Appeal NO: ABP 314485-22Defer Re O/H ☐Having considered the contents of the submission dated/ received 02/04/2024from St. Margaret's TheWard Residents Group I recommend that section 131 of the Planning and Development Act, 2000be/not be invoked at this stage for the following reason(s): no new material issuesE.O.: Pat BDate: 19/04/2024

St. Margaret's The Ward
Resident Group
Ward Cross,
The Ward,
Co. Dublin

**RE: FURTHER INFORMATION PROVIDED TO AN BORD PLEANALA BY THE DAA
ON PLANNING APPLICATION F20A/0668**

Figure 1 Additional 7km² of Very Significantly Affected Area

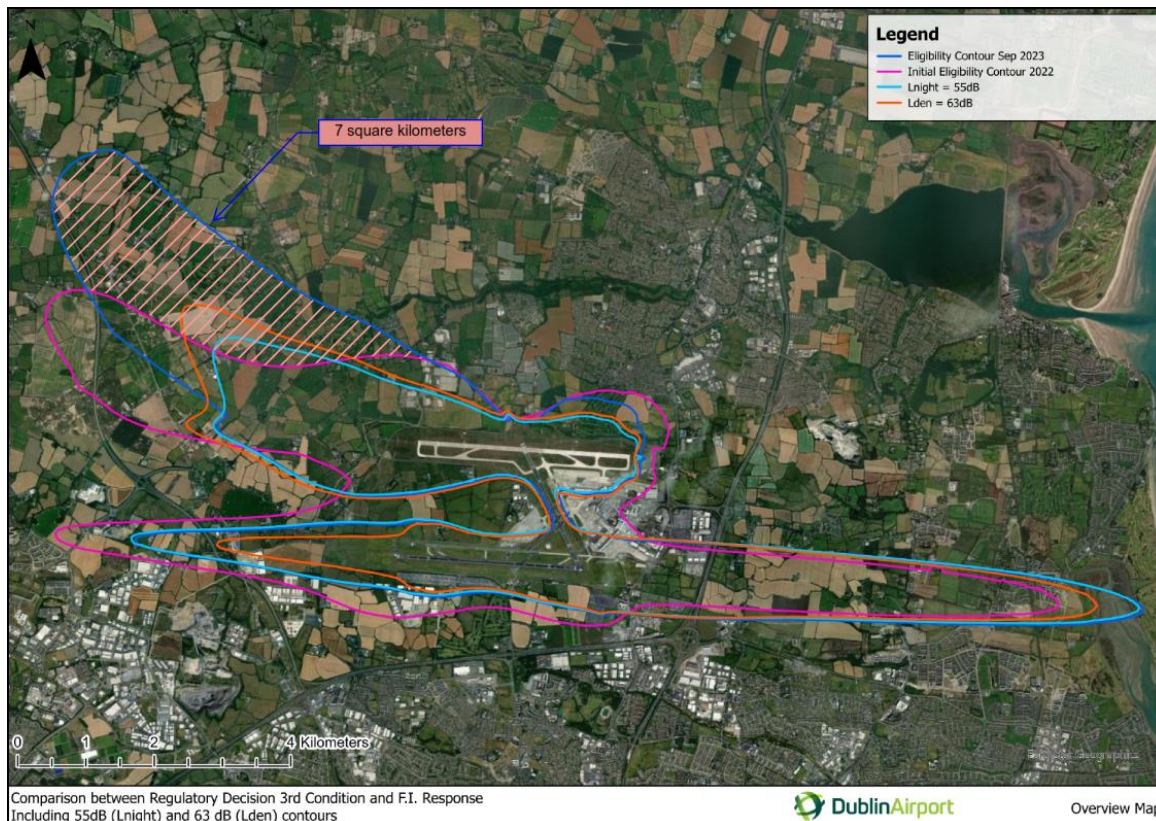
The information provided by the daa, in the form of revised eligibility maps, clearly illustrates the significant difference between the noise contours on which the ANCA regulatory decision and Fingal County Council planning decision were based. This confirms the central point of our appeal, the assessment has adopted different flight paths to those which were permitted as part of the North Runway EIS in 2007. The impact of changing flight paths is that areas find themselves significantly impacted by aircraft noise when they never expected to be impacted. In fact, over 7km² of newly affected areas are now so significantly affected they qualify for mitigation. Figure 1 illustrates the extent of this new area.

Figure 3 Daytime Noise Contours Relevant Action Supplemental EIAR 2023

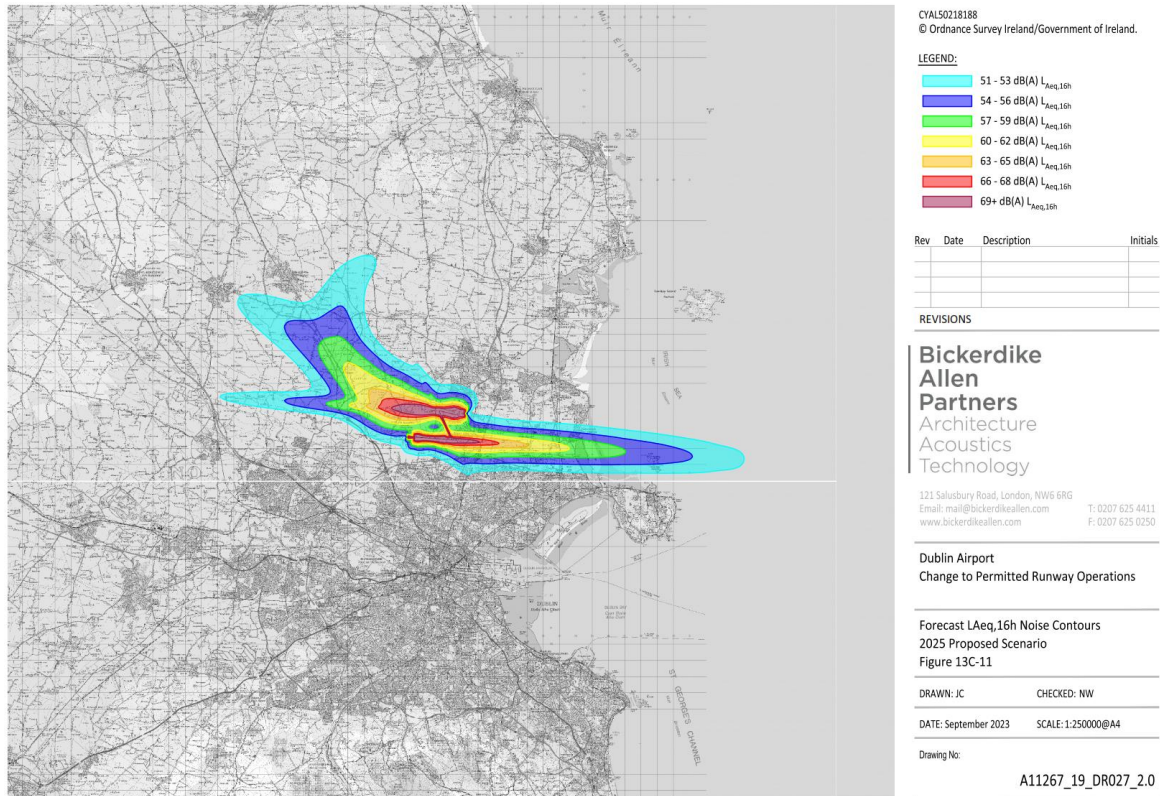
In the context of this appeal we contend that the significance of daytime impacts which result from the change in flight paths has not been adequately assessed.

Figure 3 illustrates the same noise contours submitted as part of the supplemental EIAR DAA submitted in September 2023 as part of this appeal.

Figure 4 Comparison of 2024 57dB LAeq,16hr Noise Contour - 2007 EIS vs 2023 EIAR

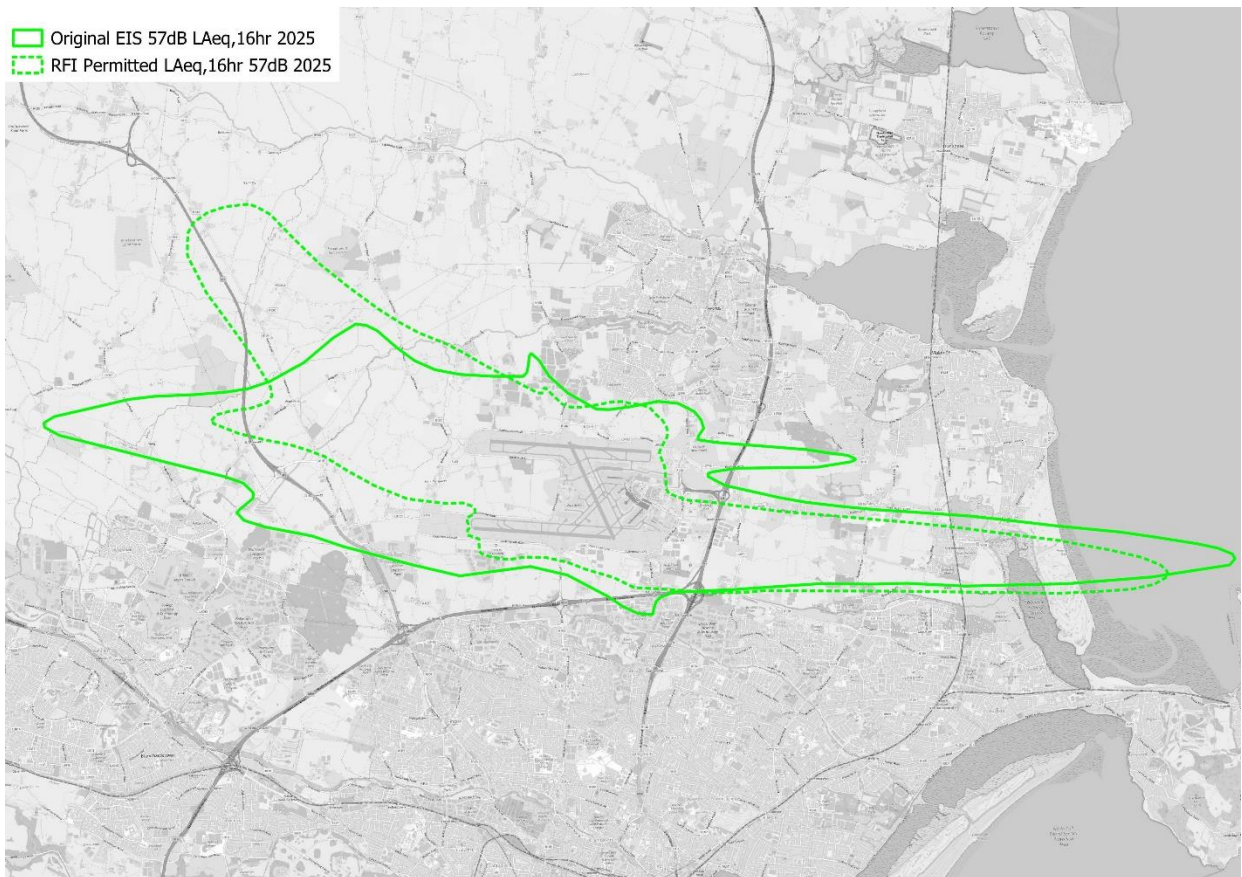
To help illustrate the large difference in the shape of the daytime noise contours Figures have been created by overlaying both sets of noise contours for the 57dB and 63dB $L_{Aeq,16hr}$ contours. The difference is obvious with many areas now exposed to higher daytime noise levels as a result of different flight paths. The significance of the daytime noise impact has not been assessed.

It is clear that there are areas now experiencing very high relative changes in the daytime noise level expected based on the original North Runway EIS versus the proposed development. This very high impact rating is not assessed for significance with is a fundamental flaw in the assessment.

Figure 6 Comparison of Monitoring Locations to DAA Summer 2023 Noise Contours

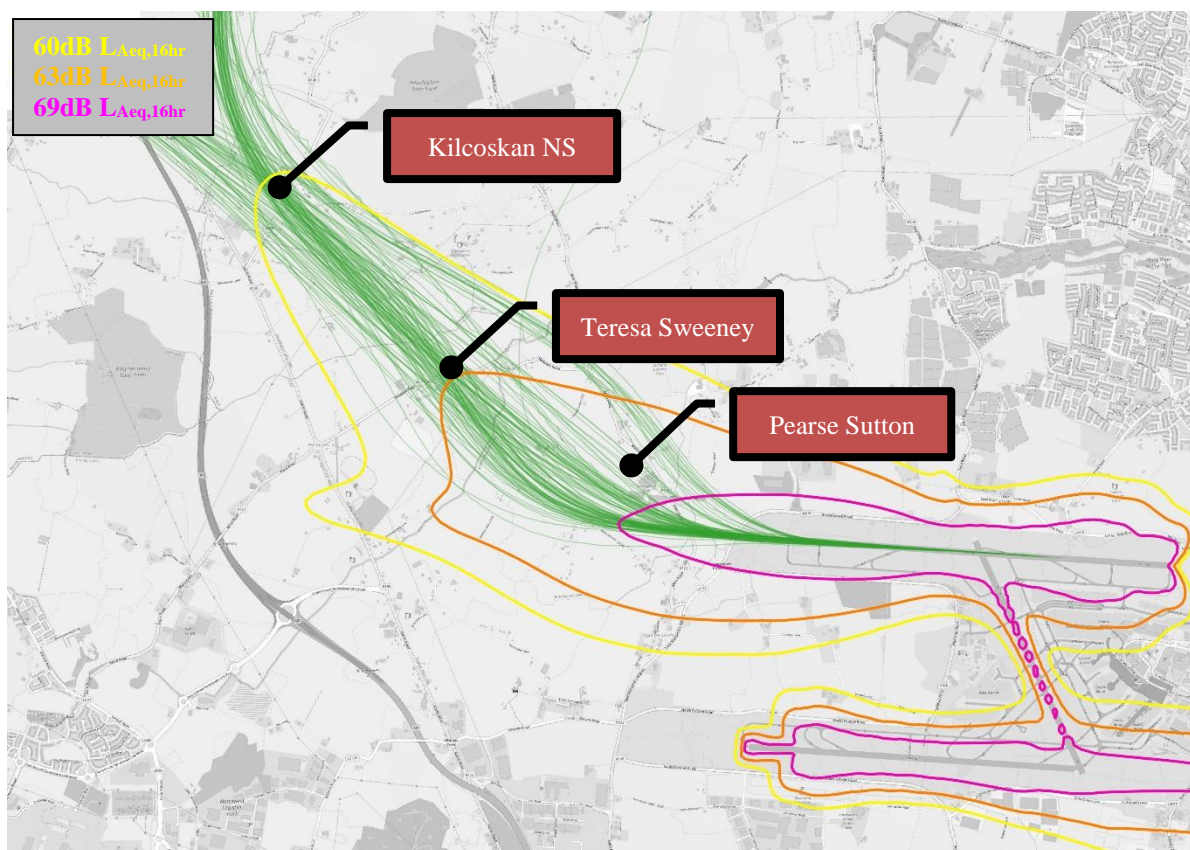
Figure 6 presents the locations of the noise monitors with westerly departure flight paths also indicated in green. Overlaid on the image are the noise contours for the Summer 2023 period produced by daa and included in the Infrastructure Application (Reg Ref. F23A/0781).

Figure 9 Single Mode 55dB L_{night} Contour

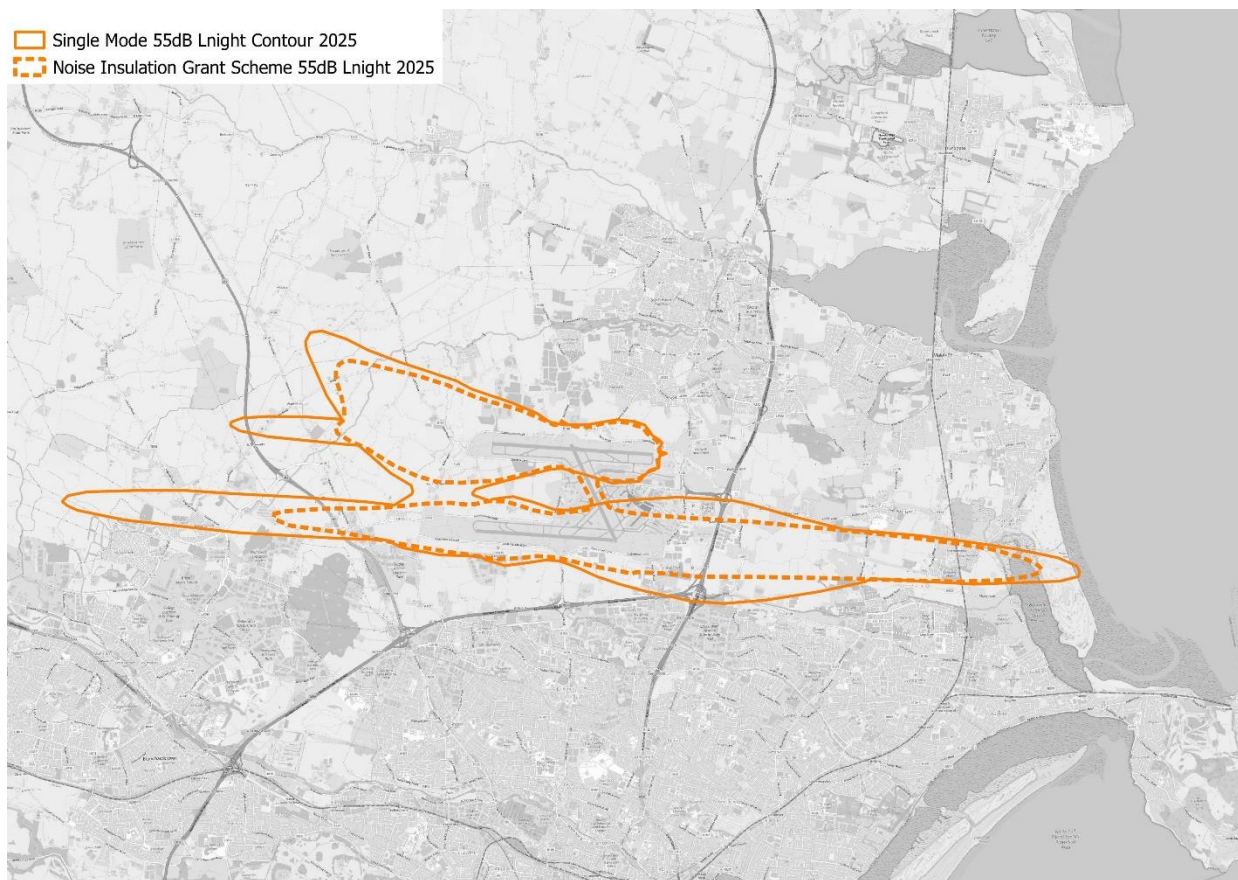
It is possible to combine the 55dB L_{night} contour from both easterly and westerly scenarios to determine a worst-case single mode 55dB L_{night} contour. Figure 9 presents a comparison of the 55dB L_{night} contour proposed by DAA as a qualifying metric for the noise insulation grant scheme with the single mode 55dB L_{night} contour.

Reviewing the areas it is clear that many more dwellings can be exposed to 55dB at night than the current eligibility contour for RGIS would determine. A similar exercise should be done for the second eligibility criteria of areas that experience 50dB L_{night} and an increase of 9dB or more above the expected noise level.

The result of our analysis shows that DAA dilute significantly the areas that may experience significant noise levels by adopting an approach that uses a modal split. We submit that it is necessary for the planning authority to redefine the definition of all noise contours used for mitigation measures to ensure that single mode contours are produced. This would align with the approach FCC used for the Noise Zones around Dublin Airport and ensure that all affected areas are mitigated for noise exposure they may receive on any given day.

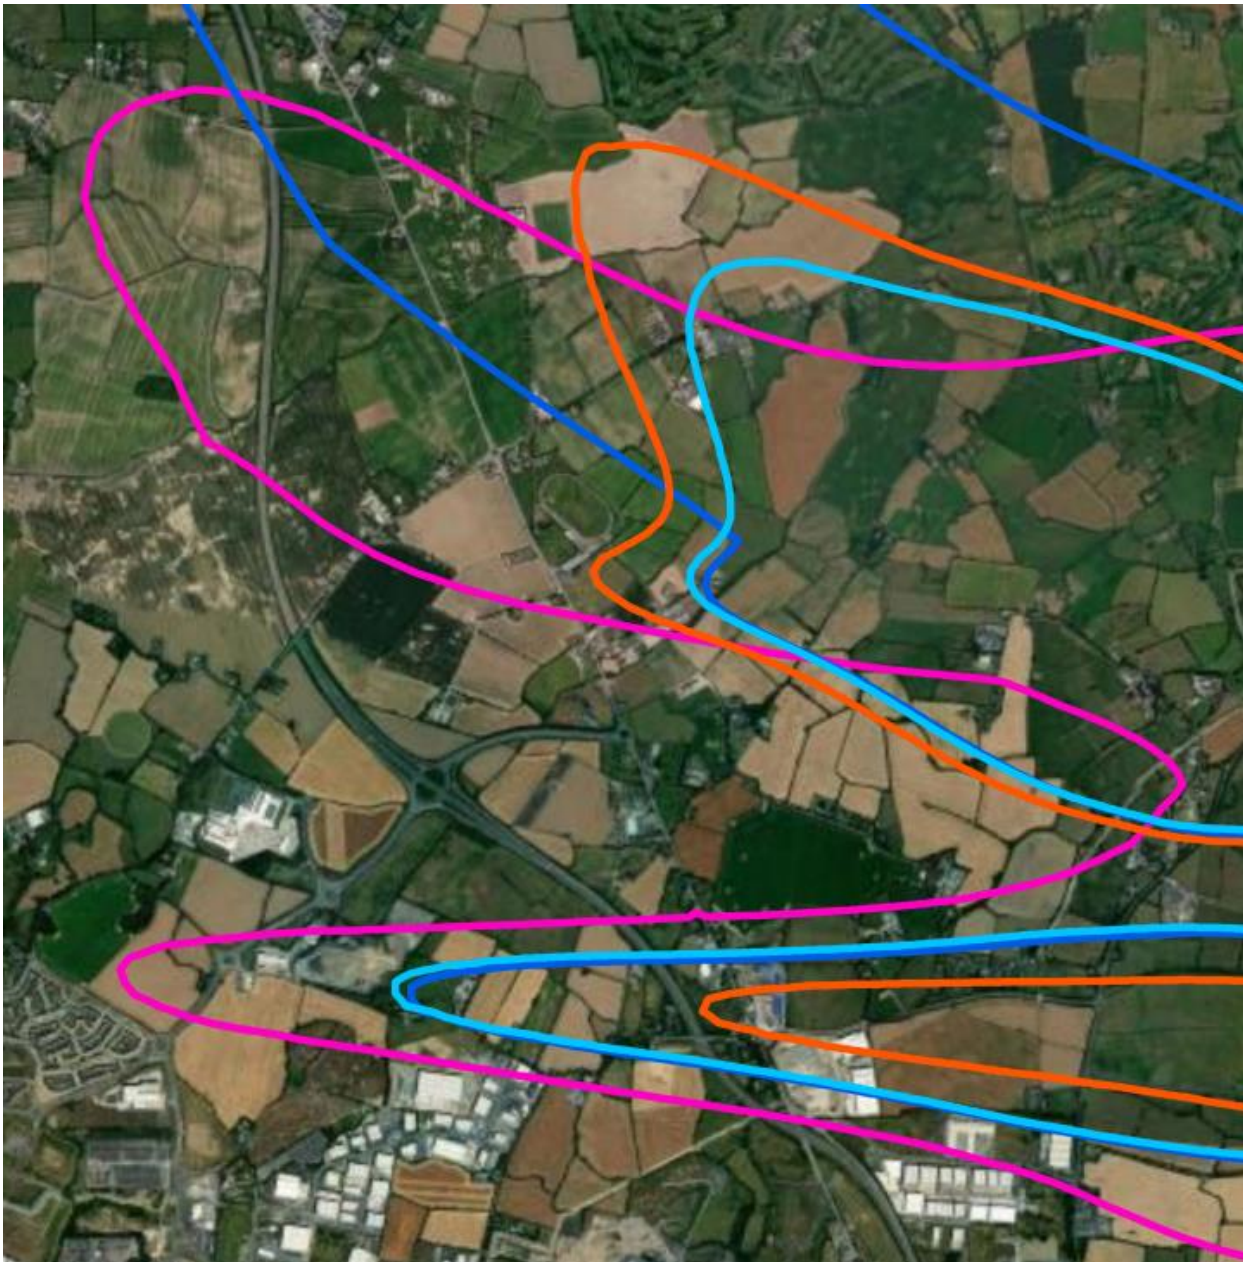
Another worrying feature is that many of these homeowners are not aware that they may be now excluded from the insulation schemes and weren't afforded the opportunity by the Board to make a submission on these maps.

Here is a visual closeup of the areas to the west of the North and South Runways that now find themselves excluded from the nighttime insulation scheme based on the new maps provided by the daa (area between the pink and blue lines):

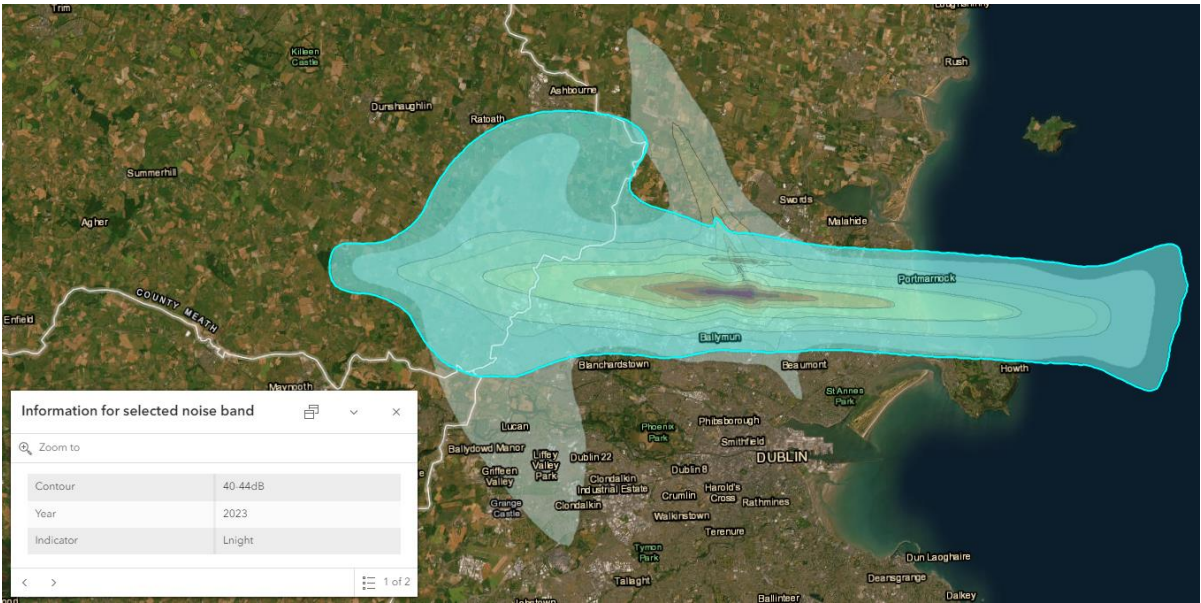
Below is an image of the 2023 Lnight contours superimposed on the 2019 Lnight contours.

From the image one can see that in 2023 a greater area to the North-West of Dublin Airport was exposed to greater than 55 dB Lnight. The image also shows that the contours extended on both ends of the South Runway in 2023.
